March 22, 2021

Town of Hingham
Planning Board
210 Central Street
Hingham, MA 02043
(Submitted Electronically via Email)

**RE: 100 Industrial Park Road – Amazon Last Mile Facility
Comments/Questions Regarding Special Permit A3 Parking Determination & Waiver**

Copies of Sheets A1.02 and A11.03
Showing “Tenant Hub”
On Record at the Hingham Building Department

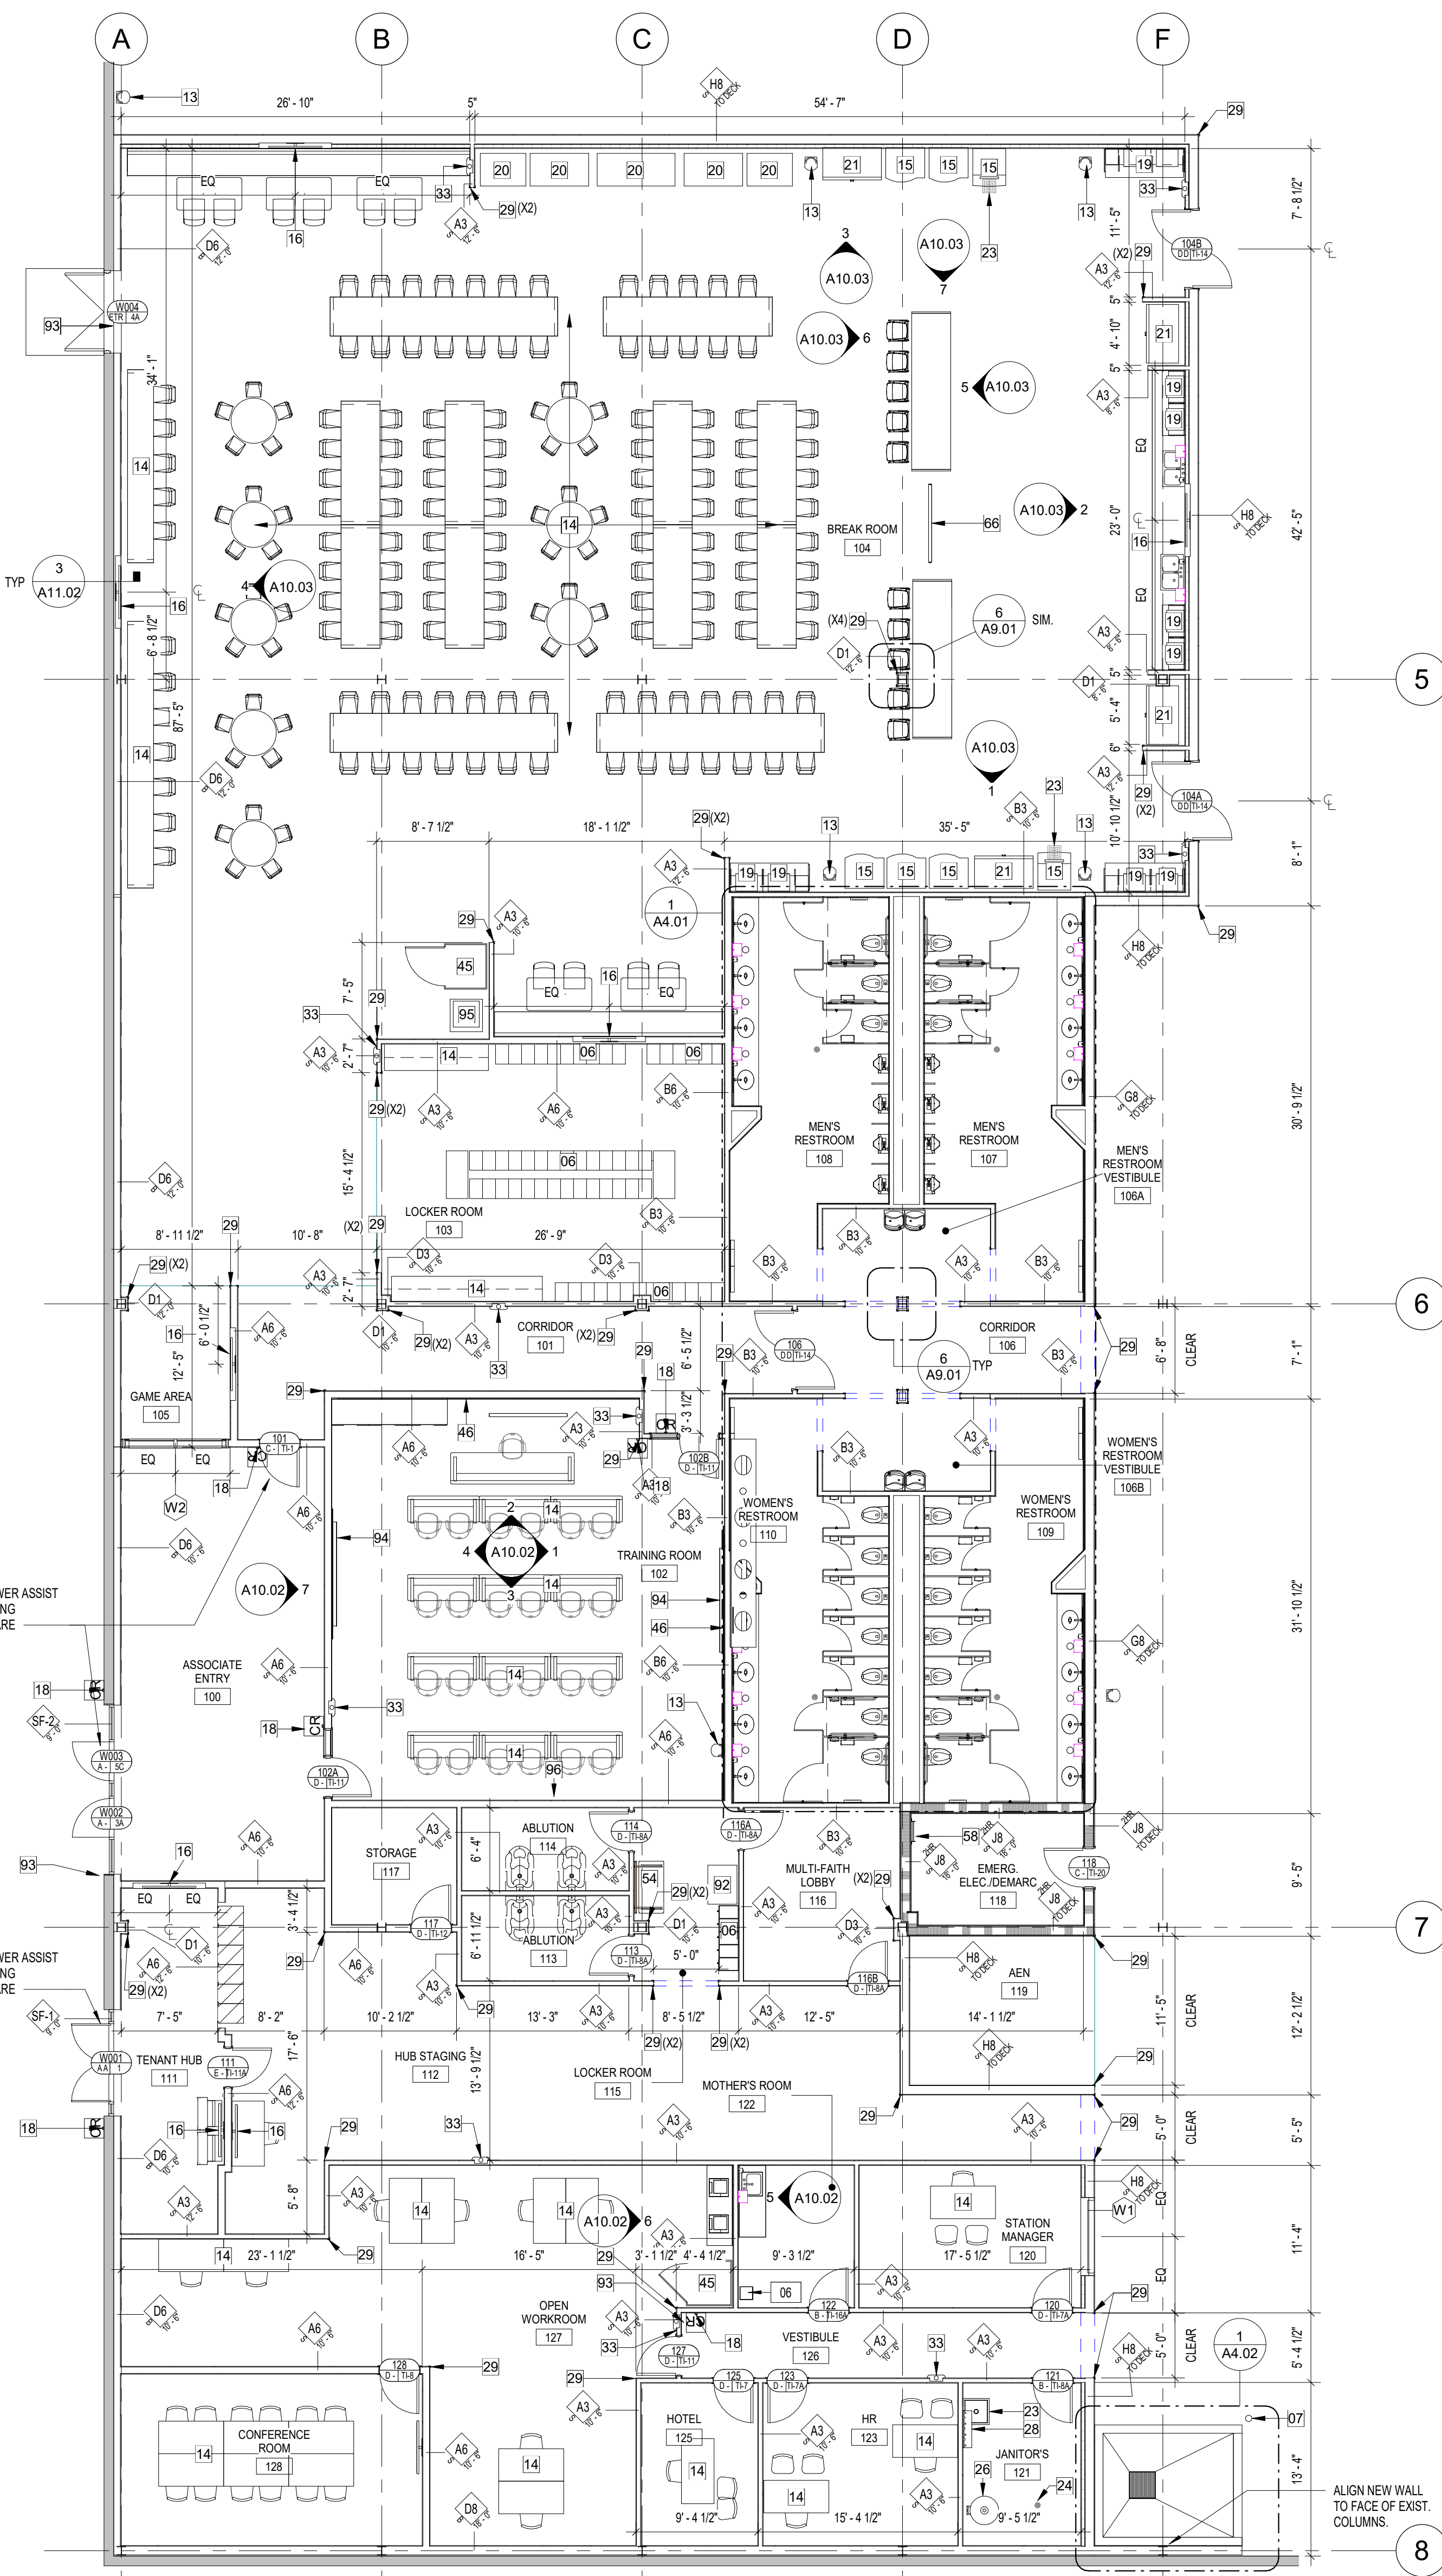
- See attached copies of sheets A1.02 and A11.03 (Attachment A) prepared by BL Companies that are on file with the Hingham Building Department as part of the pending Building Permit Application(s).
- The BL Companies Building Plans identify and detail a “Tenant Hub.” The detailed views of this hub clearly identify “Customer Kiosks” as well as “Customer Pickup Lockers” and package “Return Slots.”
- We ask what parking requirements have been determined for this public-facing element, where spaces have been provided and what provisions are provided for directional signage to direct the public accordingly?
- Why have no vehicle trips for this use been accounted for in the Supplemental Traffic Information report dated February, 2021?
